Outcome of Exhibition

Planning Proposal 160 Burwood Road, Concord (Bushells)

Report on Submissions

October 2022

Foreshore Building Line:

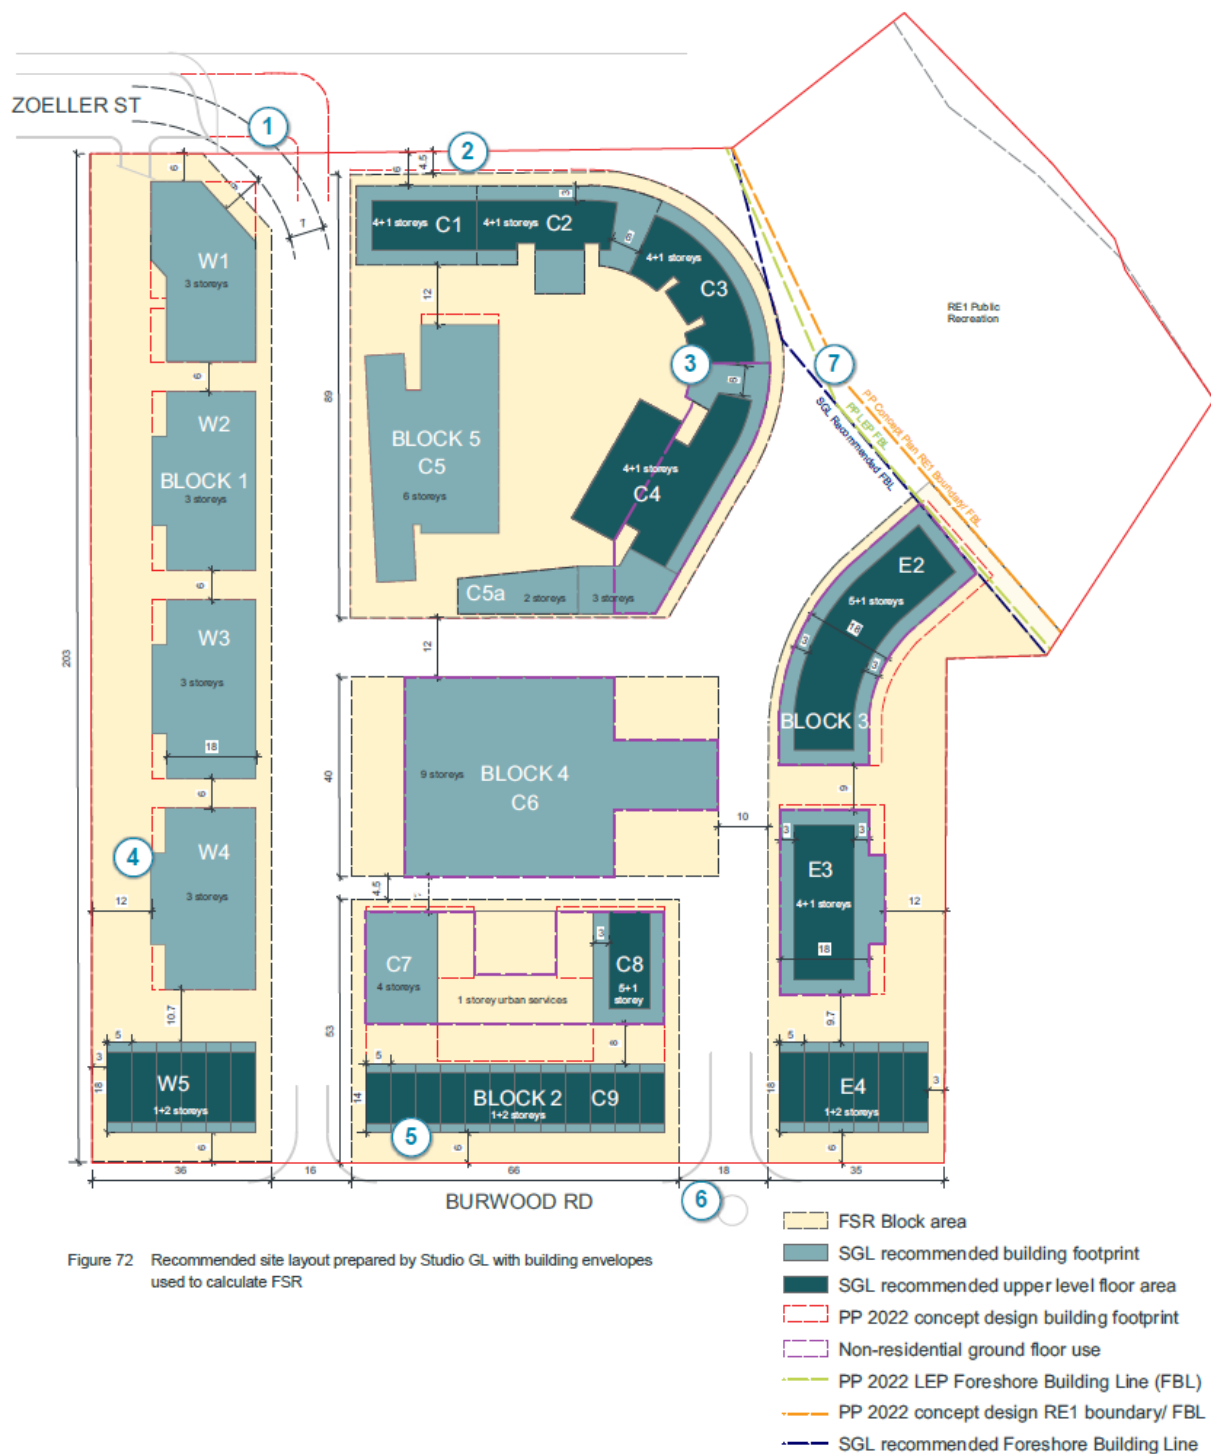
- Adjust the Foreshore Building Line so that it follows the outer edge of the building footprint facing Exile Bay.
